Fish Passage Plan (FPP) Change Form

Change Form # & Title: 24IHR004 – Name change of fish ladder entrances
Date Submitted: 27-DEC-2023
Project: Ice Harbor
Requester Name, Agency: Ken Fone, USACE
Final Action: **FINALIZED 1-FEB-2024**

Figure IHR-1. Ice Harbor Lock and Dam General Site Plan

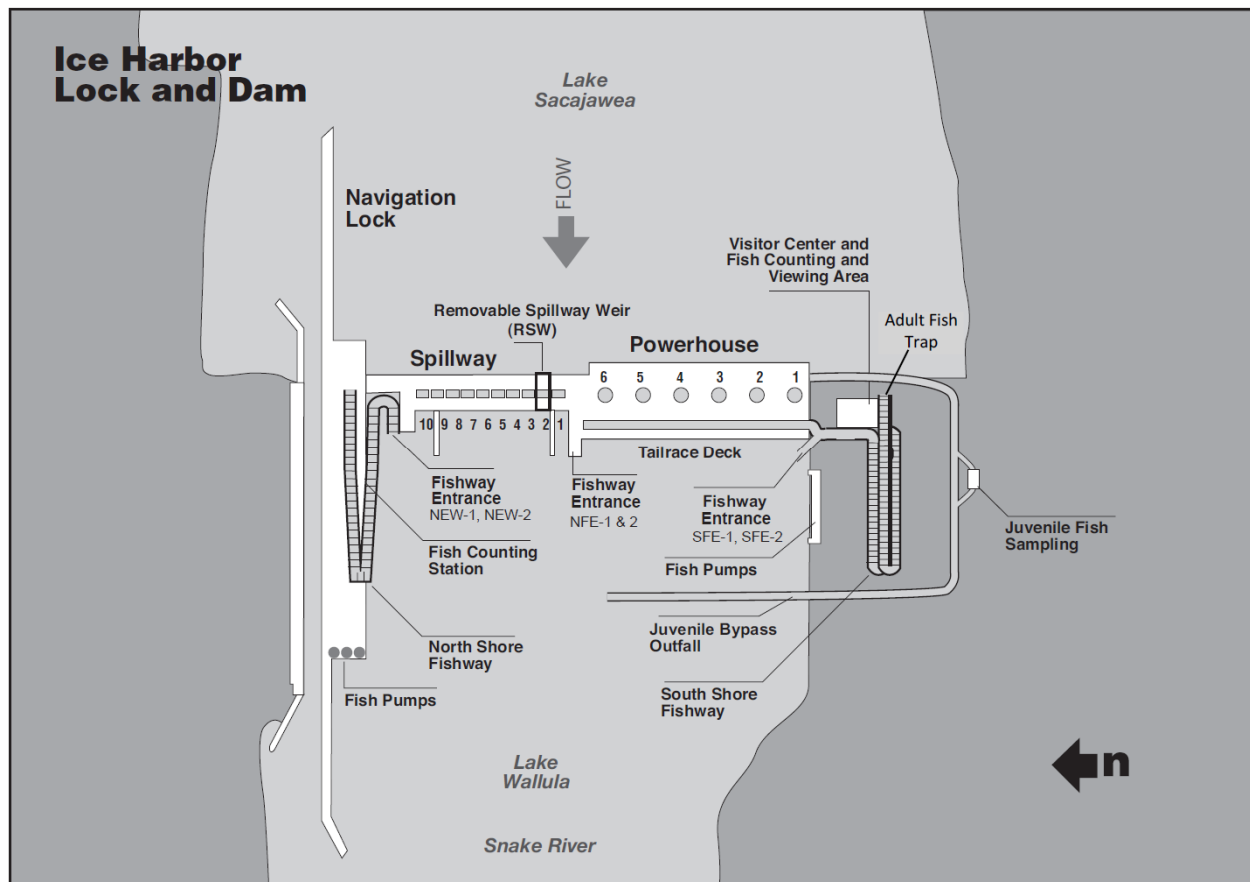
Change "NFE-1 & 2" to "CFE-1, CFE-2". Change "NEW-1, NEW-2" to "NFE-1, NFE-2"
